**AGENDA  
FARRAGUT MUNICIPAL PLANNING COMMISSION**

**May 19, 2016  
7:00 p.m. Farragut Town Hall**

**SUBJECT: STAFF COMMENTS ON THE SITE PLAN FOR THE FARRAGUT TOWN CENTER, 103 S. CAMPBELL STATION ROAD**

RE: Staff Comments on the Site Plan for the Farragut Town Center, 103 S. Campbell  
Station Road  
BMa Project Number 160900

**C1.01**  
 SITE LAYOUT & PAVING PLAN  
 4 OF 17

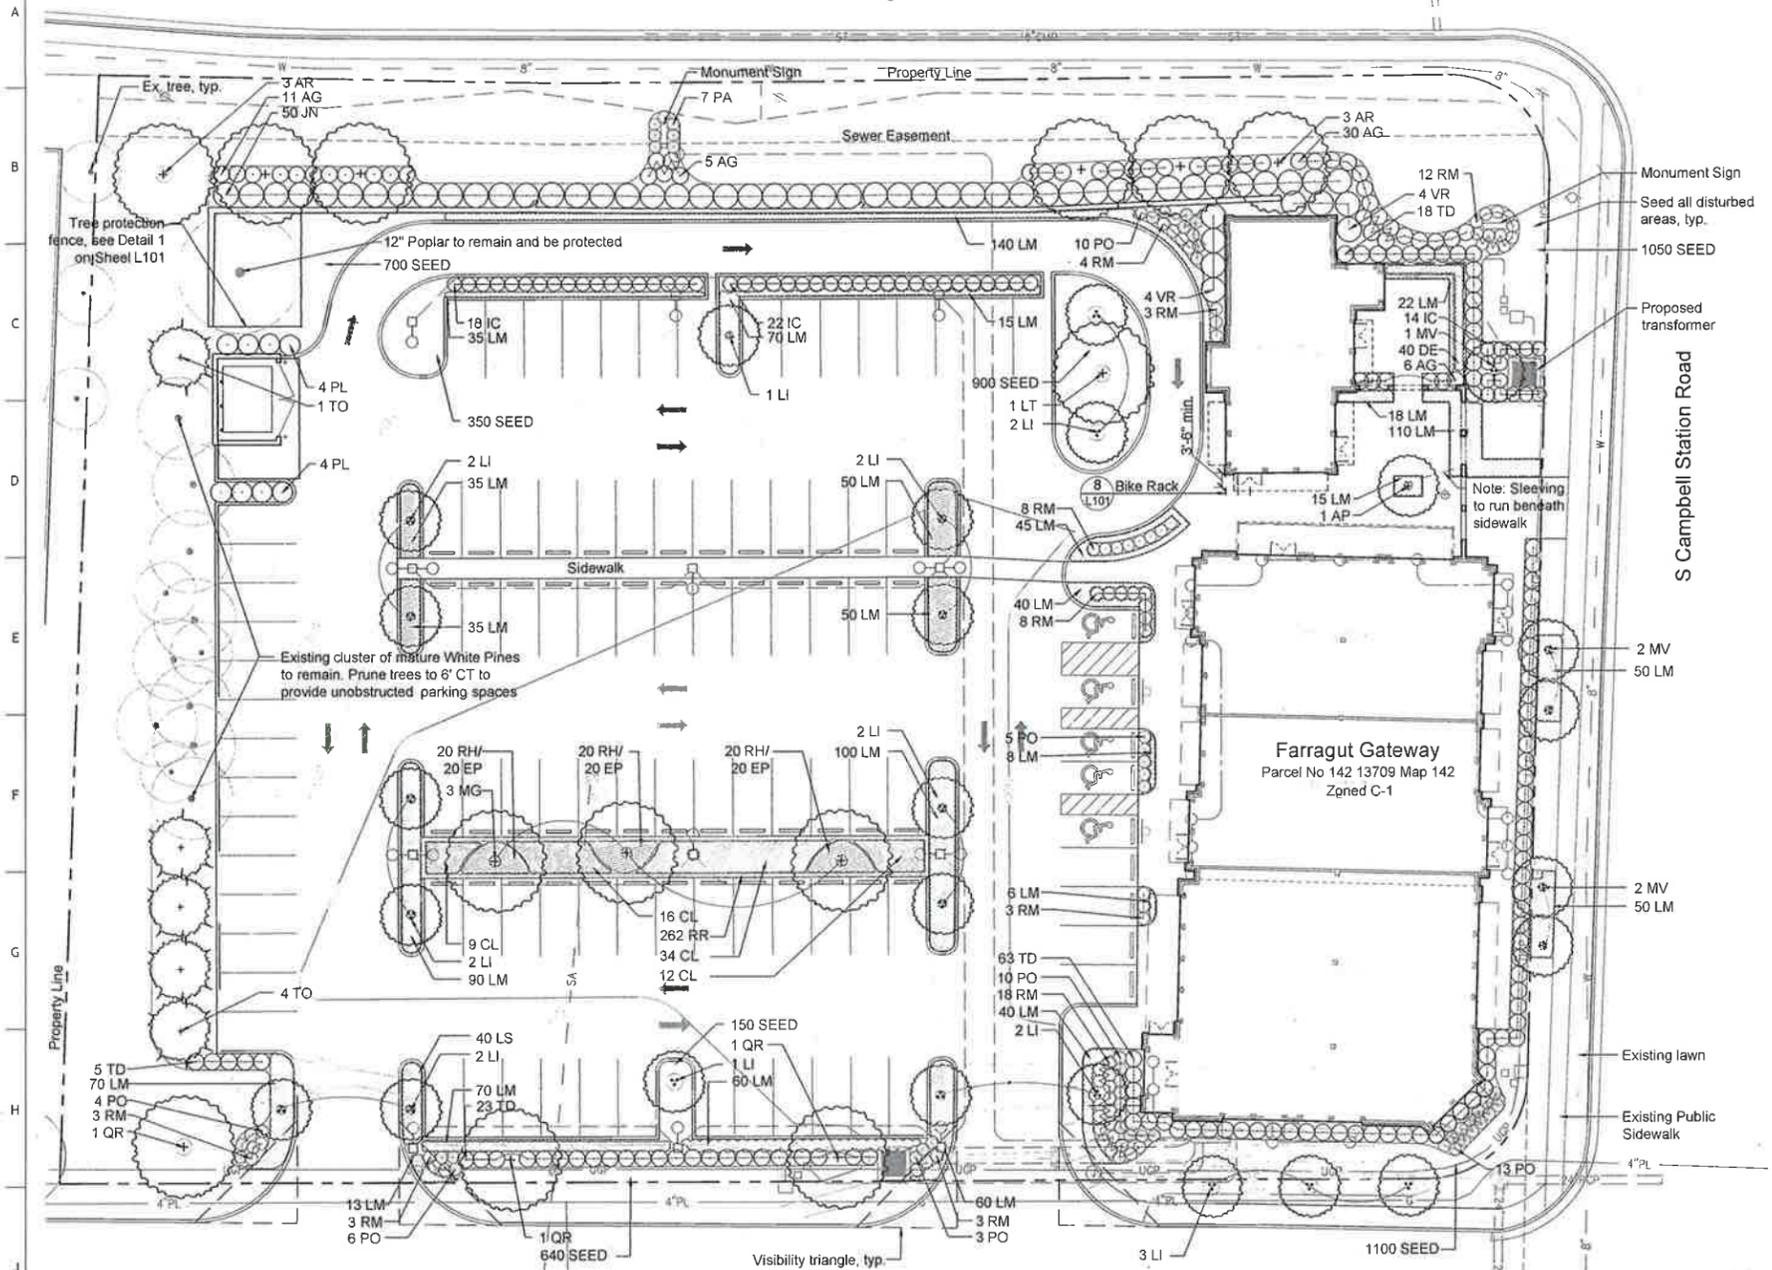
- 18) In the parking summary, please include the bicycle parking requirements and what is being provided;
- 19) On Sheet C1.01, please show the proposed location for bicycle parking;

- 18) Provided on sheet C1.01.
- 19) Shown and noted on sheet C1.01.
- 20) The retaining wall has been removed and replaced with a new grading design (C2.01).

1 Landscape Plan  
Scale: 1" = 20'-0"

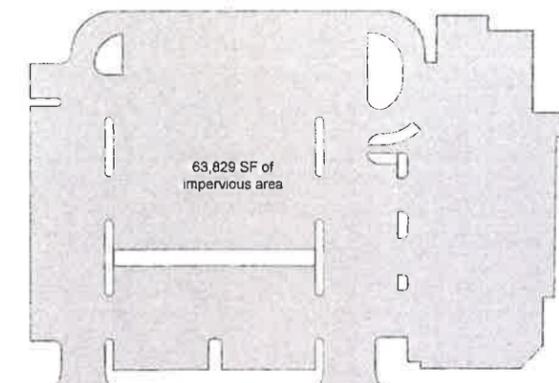
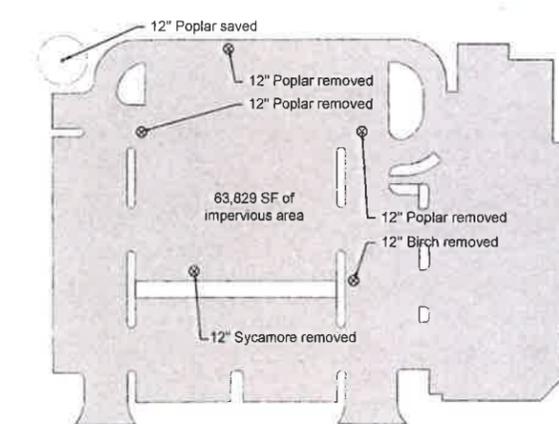
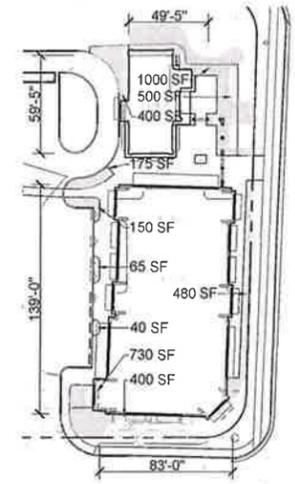
- 22) Please remove reference to signage at this point. These will be addressed with the sign permit reviews;
- 23) Are there measures that can be taken to either relocate or soften the appearance of the proposed transformer along S. Campbell Station Road;

- 21) This has been noted on sheet A101 (General Note #3.)
- 22) All references to signage have been removed.
- 23) Additional landscaping has been provided to help soften the appearance of the proposed transformer along S Campbell Station Rd (L101).

4 BUILDING ELEVATION - SOUTH  
A301 0 2 5 10 20

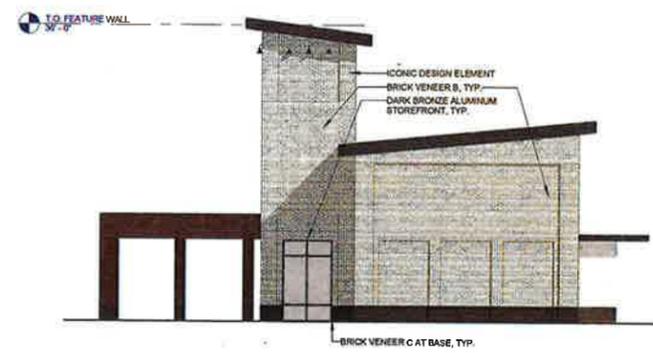
- 11) Please ensure that all buildings have at least the appearance of being 2-story as viewed from all elevations. The corner "coffee shop" building does not appear as 2-story and will need to be modified accordingly;

- 30) On the building elevations please add a note which specifies that at least 75% of the building materials (excluding doors and windows) to be used on all building elevations is face brick;

- 10) "Not for Construction" has been replaced with a signed stamp on all sheets.
- 11) The corner coffee shop was modified to incorporate a 2-story appearance. Colored elevations can be found on sheet A301.

- 28) Revised on sheet ES102.
- 29) Fixture "SC" is shown on sheet ES102 and incorporated into the architectural elevations on A301.
- 30) Noted on Sheet A301 (General Note #10.)

Conceptual Site Plan

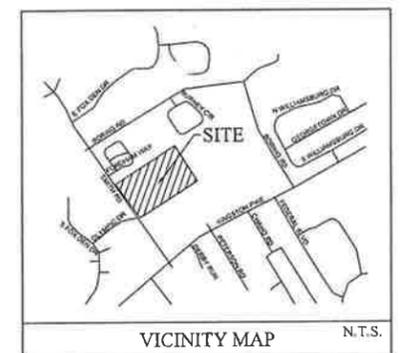
3. Please provide a more legible vicinity map.  
**The vicinity map on sheet CP-1 has been revised to make more legible.**
4. Please include pedestrian facilities along Peterson Road and stub out walking trails to all abutting undeveloped properties, including a connection to the Smith Road sidewalk in the northwestern portion of the property.

6. Please provide calls and dimensions for the Peterson Road ROW extension.  
**Dimensions and calls have been added to sheet CP-1 for the Peterson Road ROW extension.**

**We have added an additional sidewalk connection to Smith Road at the northwest end of the property, a sidewalk connection to the property to the east at the northeast end of the property, a sidewalk along Peterson Road, and extended the sidewalk from the cottages along the south property line to Peterson Road.**
